Re: January Planning Commission Meeting

1. Site Plan for Lots 1R and 11R, Carroll Heights Subdivision. Thomas Engineering, Agent.

Application Type: Site Plan Review

SITE PLAN REVIEW
LOTS 1 & 11, BLOCK 2
CARROLL HEIGHTS SUBDIVISION
CITY OF SHERWOOD,
PULASKI COUNTY, ARKANSAS

GRADING PLAN			
LOTS 1 & 11, BLOCK 2 CARROLL HEIGHTS SUBDIVISION CITY OF SHERWOOD, PULASKI COUNTY, ARKANSAS			
APPROVED	DRAWN BY MNH	DATE 12.30.2025	SHEET NO. 4
3810 LOOKOUT ROAD, N. LITTLE ROCK, AR. 72116 TEL: 501-753-4463 FAX: 501-753-6814 SCALE: 1" = 20'

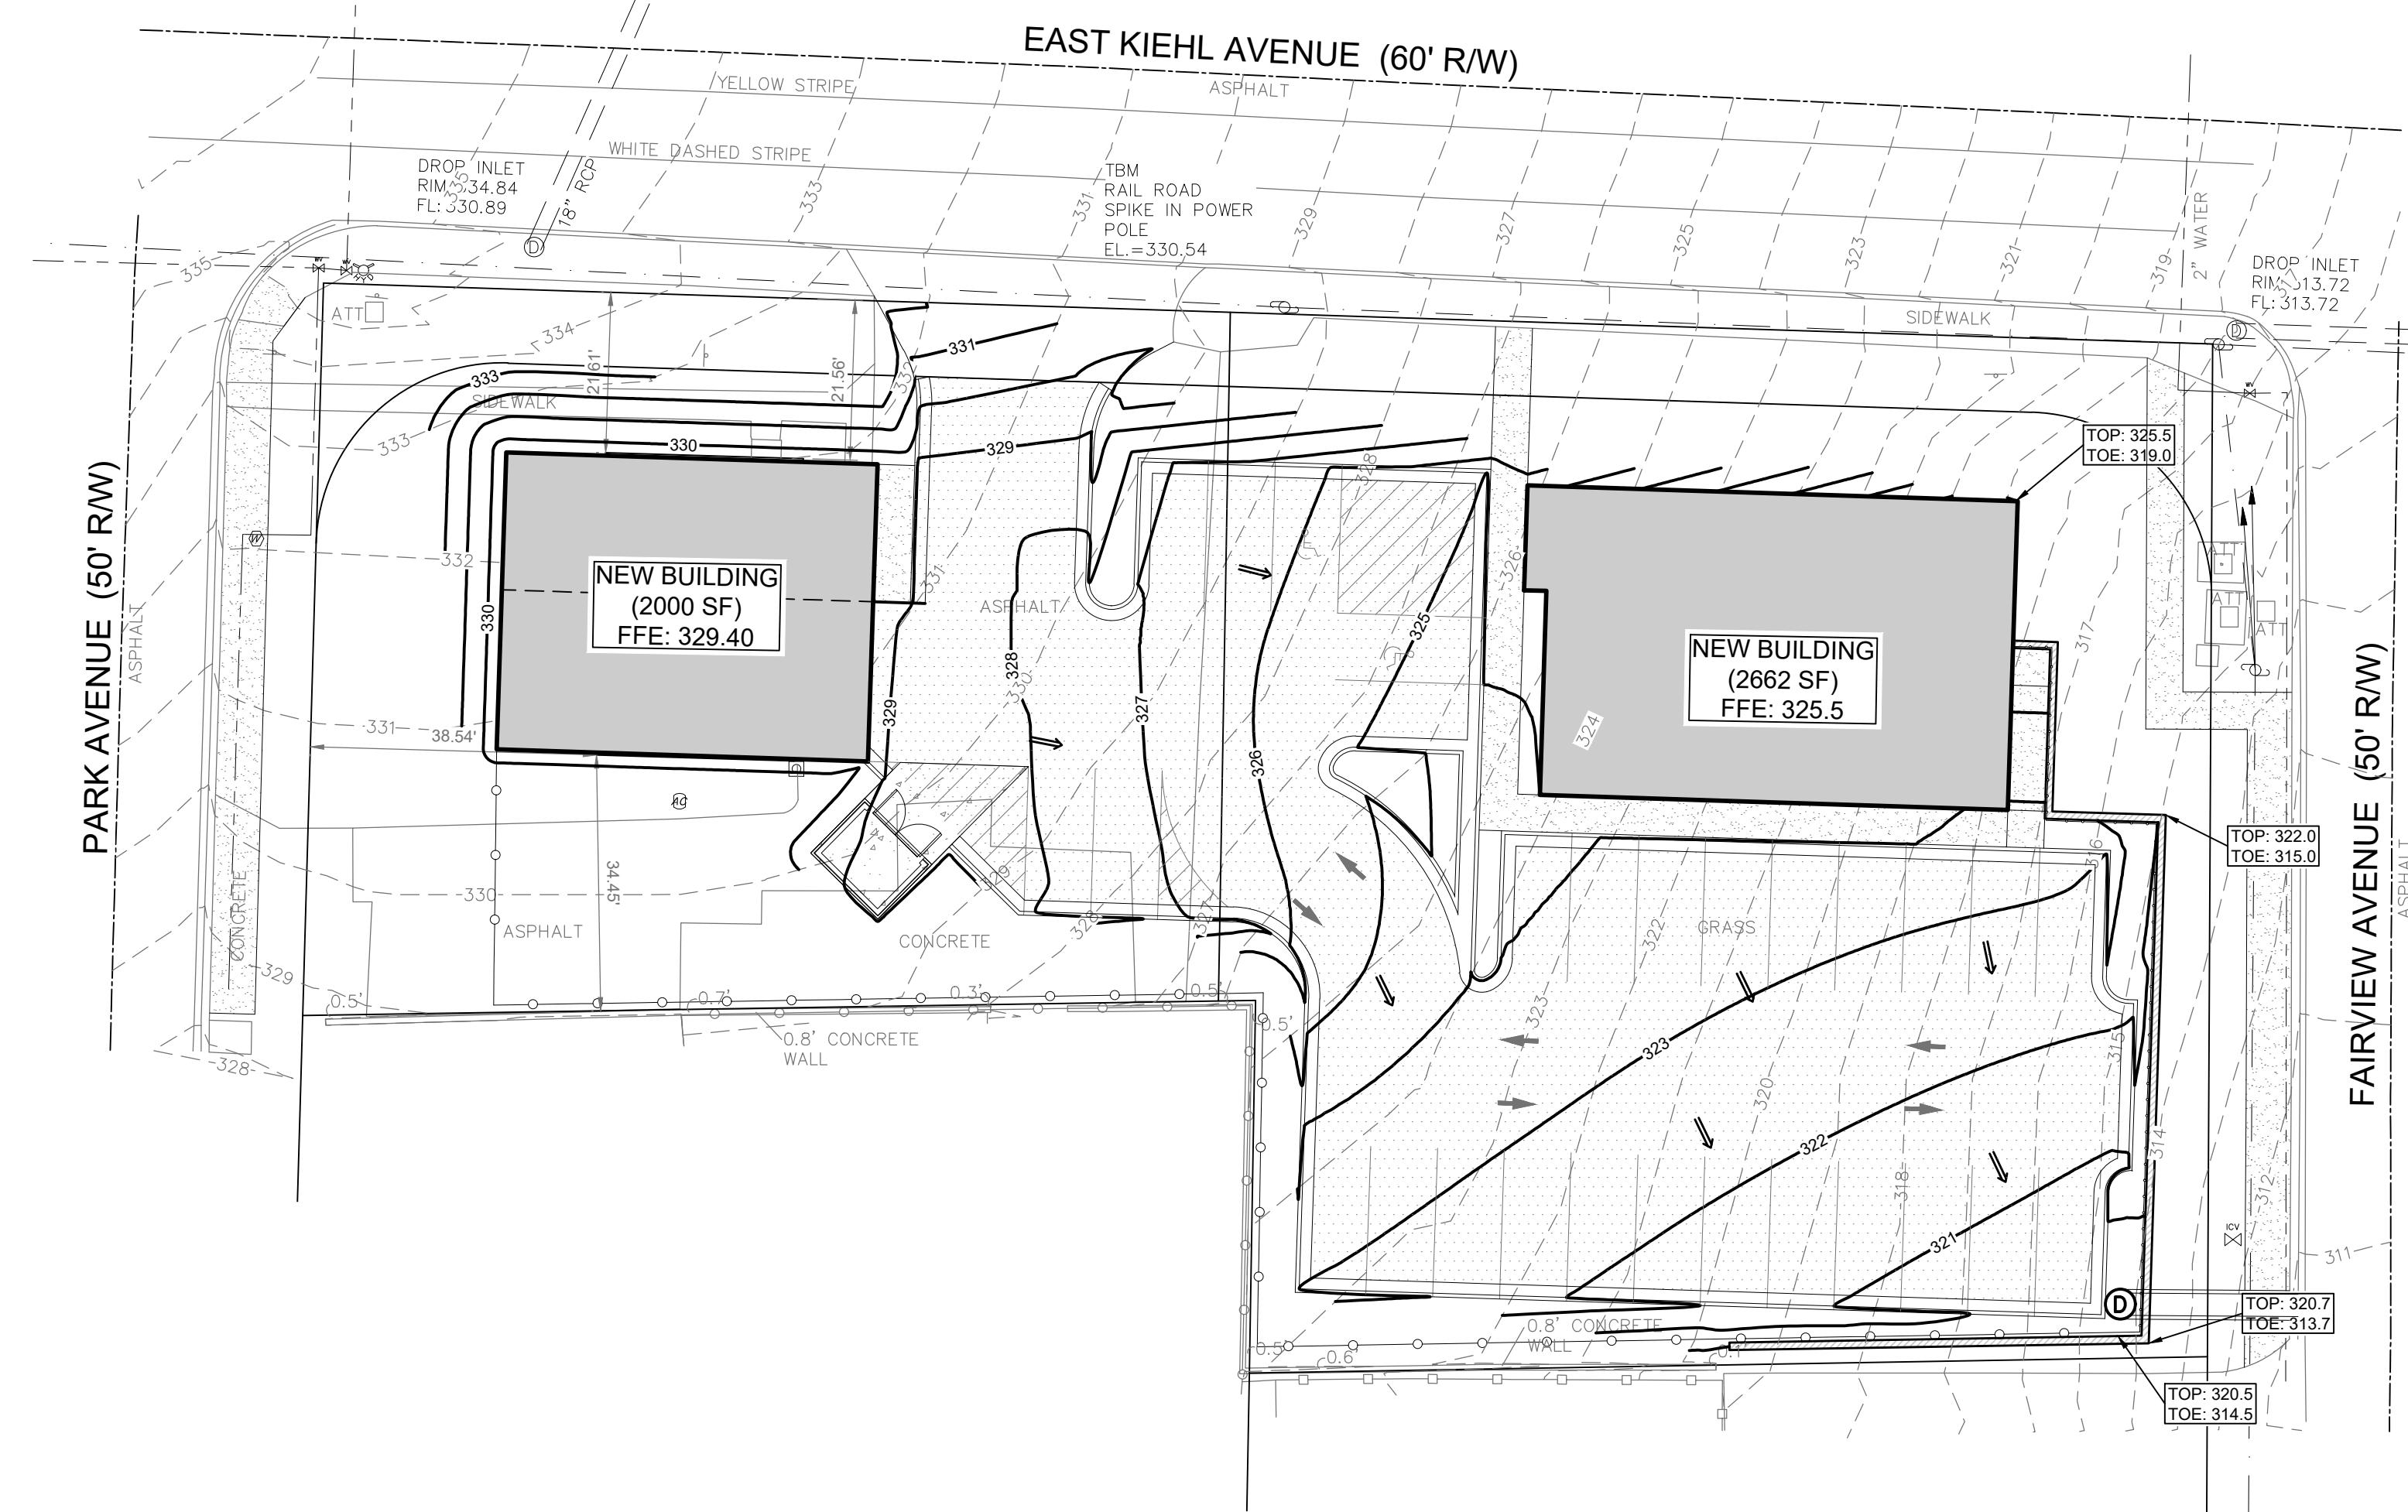
4. Engineering:
 - a. *Provide runoff calculations/pre- and post-drainage report. Not provided; city consulting engineer requires a complete and accurate grading and drainage plan for the site to determine the feasibility of the concept at this location given challenges presented by the lot and existing terrain.*

- b. *What is the plan to capture runoff leaving the parking area at the SE corner of Lot 11R near the proposed retaining wall? City consulting engineer requires additional information for the proposed drainage structure at the SE corner of Lot 11R; applicant indicates runoff at this point will be directed to Fairview Ave.*

- ii. *How much water is proposed to be dumped out at this location onto Fairview Ave during a 10-year storm?*
- c. *How will the site be graded where impact or cross over to adjoining property does not occur?*
 - i. *City consulting engineer requires a grading plan that captures the NE corner of Lot 11R be provided [where the new sidewalk improvement maneuvers around existing utilities]. Will the sidewalk improvement meet ADA?*
 - ii. *NW corner of the new construction on Lot 1R details a ±20% grade from E Kiehl Avenue to the NW corner of the structure (contours 333, 332, 331, 330). It is likely the proposed design will pose drainage issues.*
 - 1. *Sidewalk improvement indicates a ±20% cross slope. Will this meet ADA?*
- d. *Provide engineering plans for the proposed retaining walls. Not provided; applicant indicates retaining wall detail will be provided upon design.*

CAMILLA LANE PLAN & PROFILE CAMILLA ACRES SHERWOOD, PULASKI COUNTY, ARKANSAS

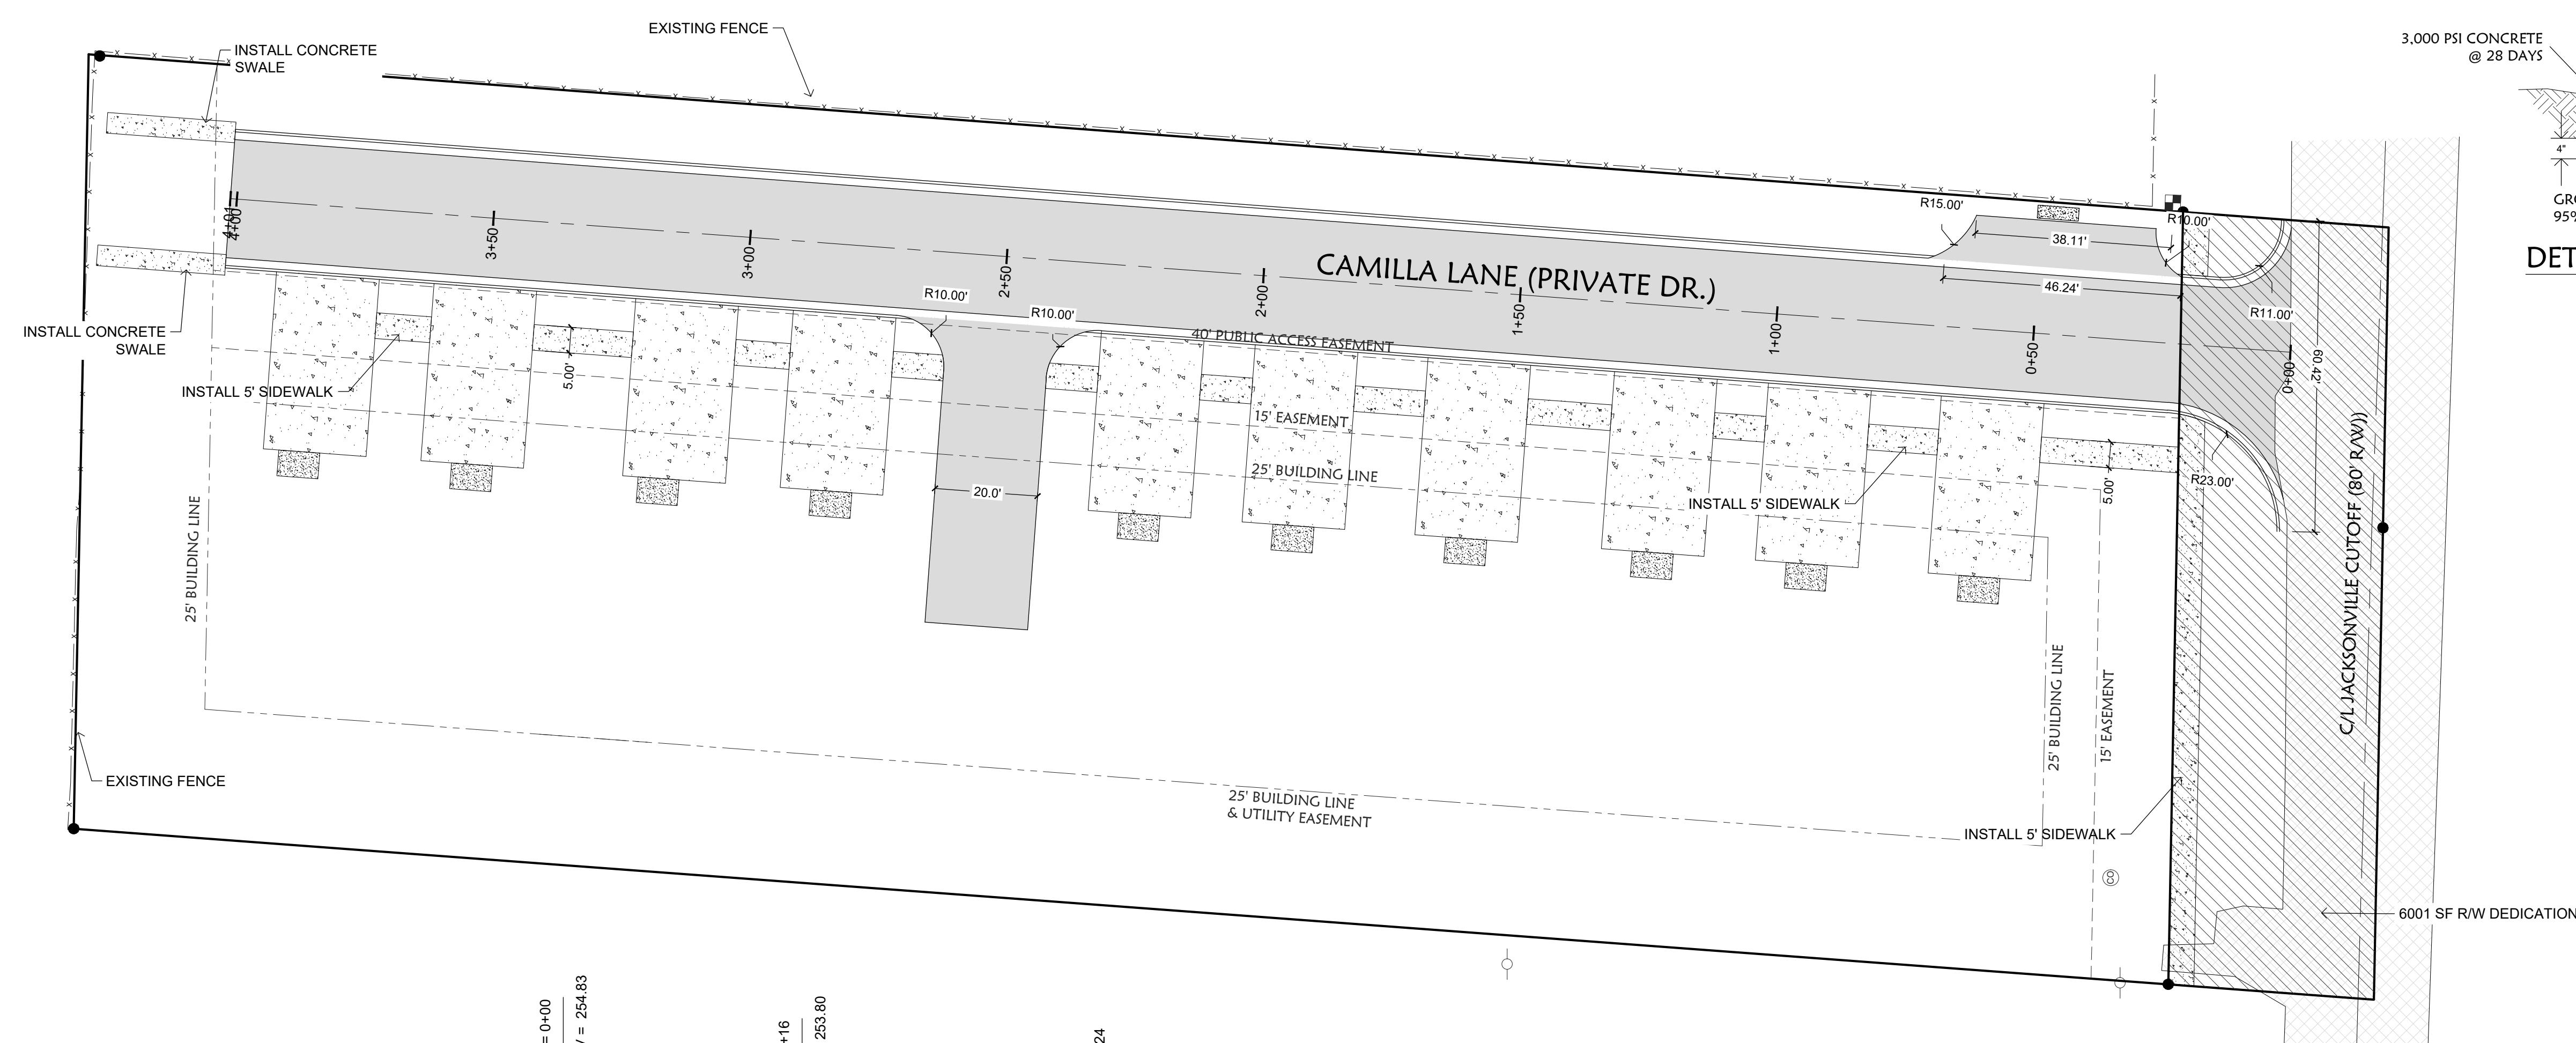
- i. *Sidewalk detail provided on Sheet C4.0 indicating a minimum 5' sidewalk proposed [for Jacksonville Cutoff Rd] as part of half street improvements.*

- c. *Provide full set of construction plans for engineering review.*
 - d. *Sheet C.4 SPL.202601.Camilla Acres indicates private road appears to meet minimum standards (27' wide, curb and gutter, etc.).*
